# GENWAL MINE

CHANGE TO THE DRAINAGE CONTROL PLAN  
FOR THE

MINE DISCHARGE WATER  
AERATION TREATMENT FACILITY

Re: Crandall Canyon Mines, C/015/032  
Change to Drainage Control Plan, Water Aeration Treatment Area

PLATE 7-5

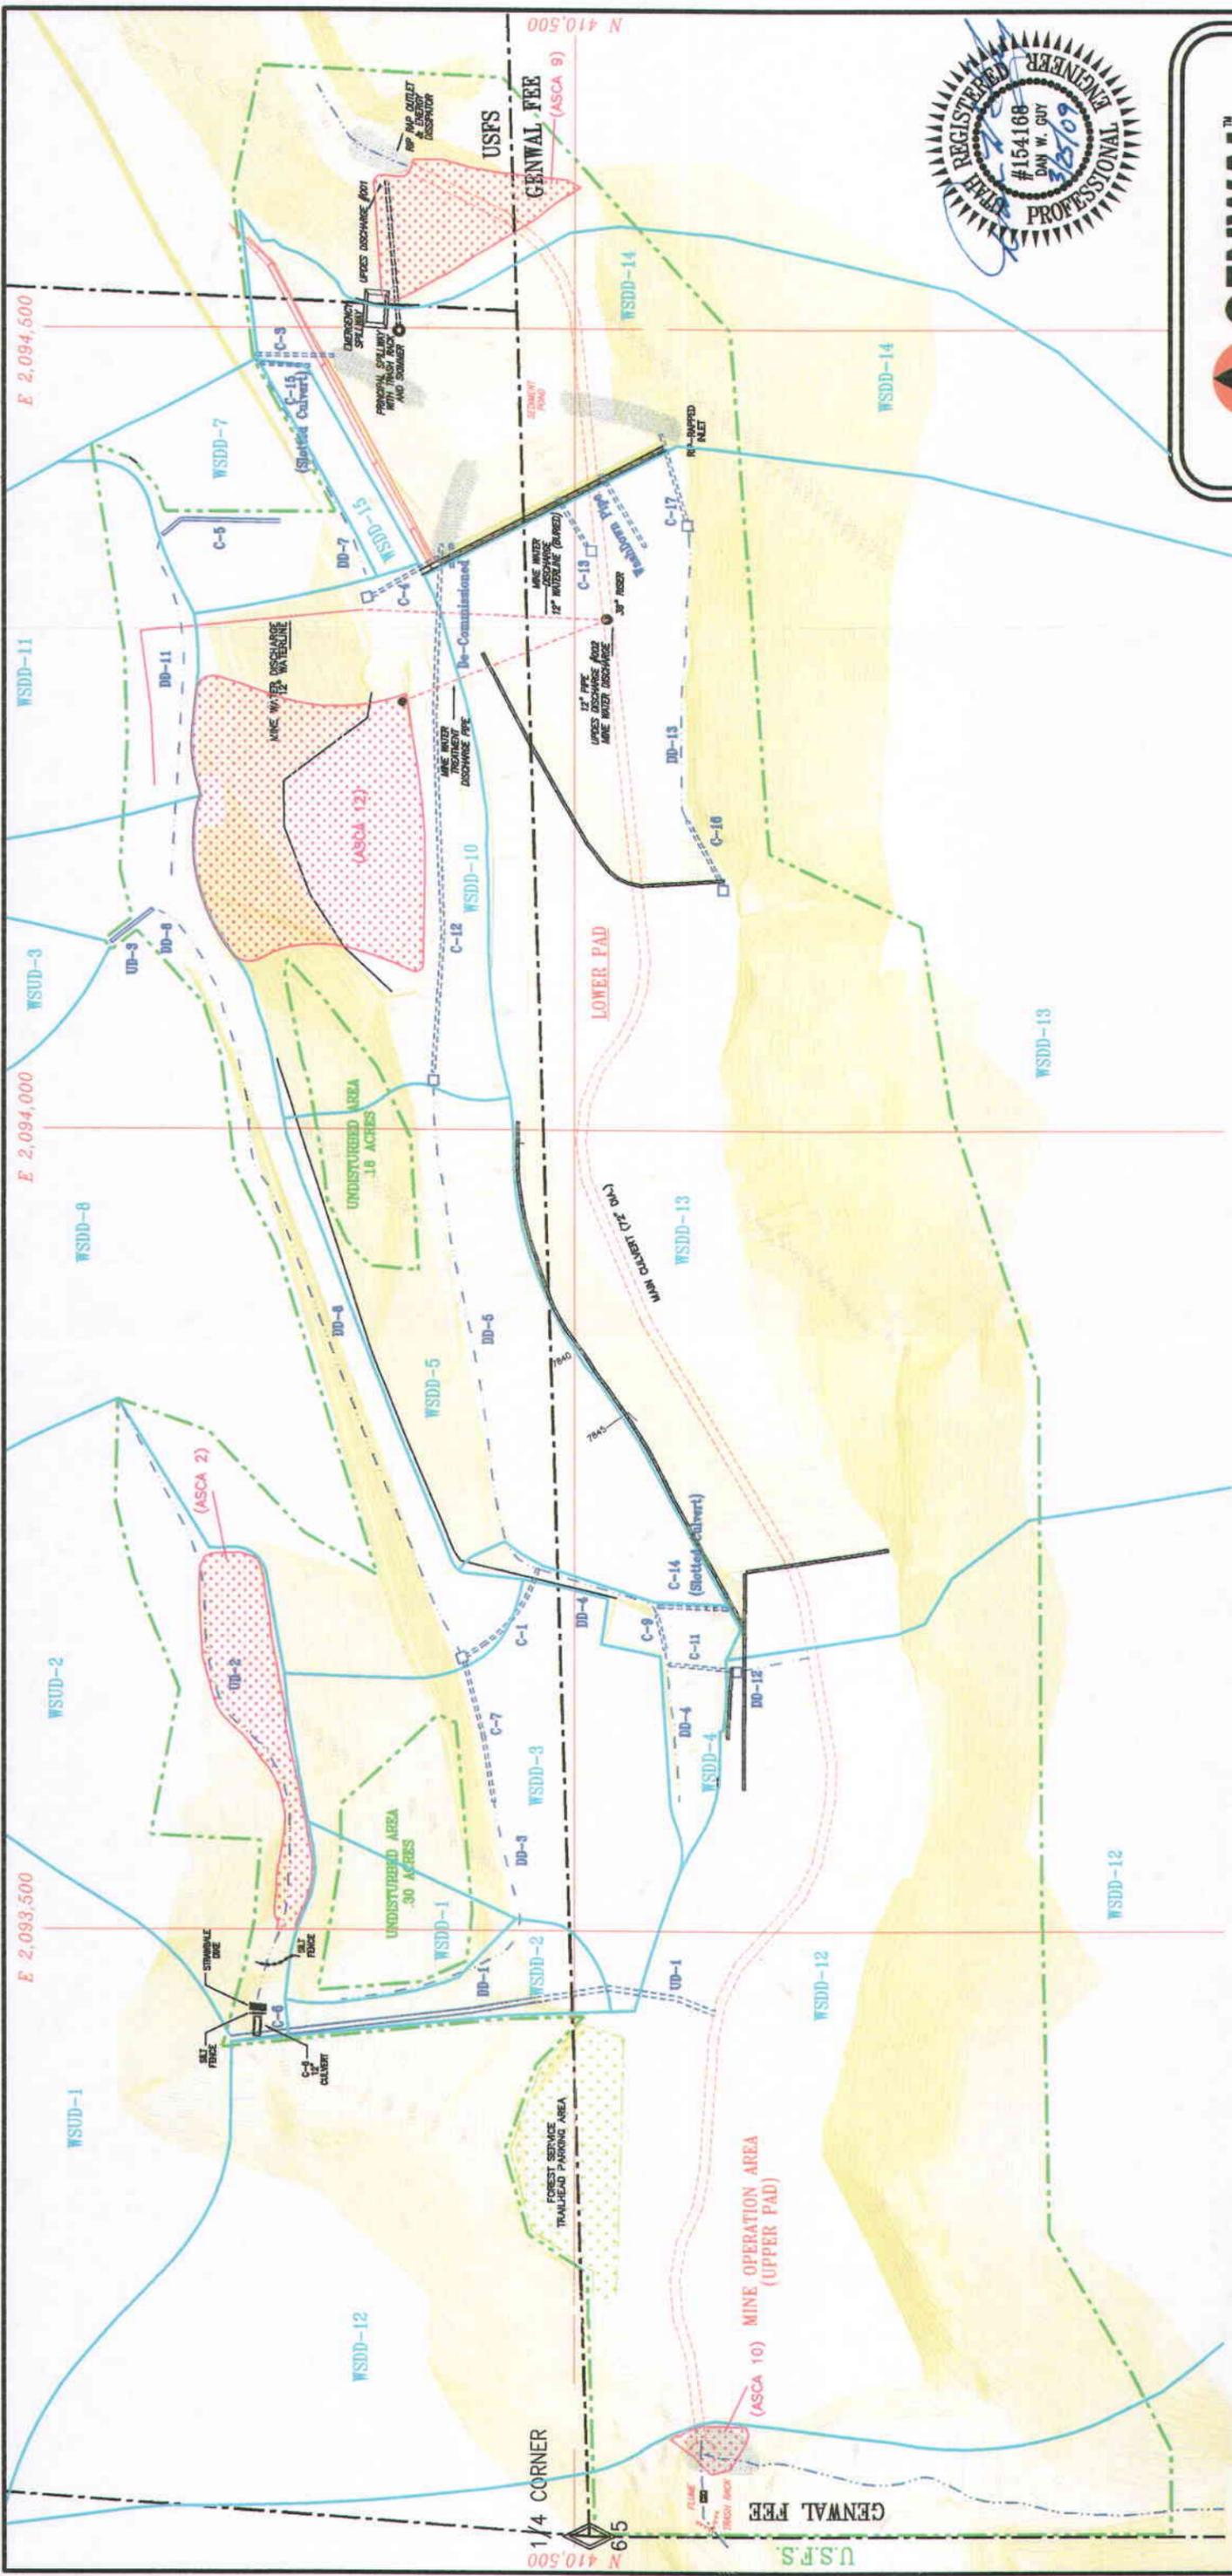
- (d) *The crescent-shaped area below the portals will be utilized as a water treatment facility for the mine water discharging from the mine and seeping from the slope below the portals. The plan is to divert all mine water into this area, where it will be channeled through a series of baffles for aeration to reduce the iron content. Once treated, the mine water will flow into the main canyon culvert at the UPDES #002 discharge location. Calculations show a minimum 12" pipeline at a minimum grade of 3 % is more than adequate to carry the expected maximum discharge of 800 gpm or 1.78 cfs. A larger pipeline may be used. This system will be isolated from the rest of the minesite drainage by topography and jersey-barriers, and since it will no longer flow to the sediment pond, it will be treated as an ASCA. The ASCA location and drainage plans are shown on Plate 7-5.*

- (e) *When the Crandall Canyon Mine Portals were sealed as a result of the 2007 disaster, it was decided to re-route the culvert system of UD-3, which diverts undisturbed drainage area WSUD-3. Culvert UD-3 now reports to Disturbed Ditch DD-8, Culvert C-1, Disturbed Ditch DD-5, Culvert C-12 and ultimately into the Sediment Pond. Calculations show that all affected ditches and culverts are adequately sized to handle the increased flow from WSUD-3 (See Tables 3, 5, 6, and 7). The Sediment Pond is also adequate to handle this additional flow (See Table 11).*
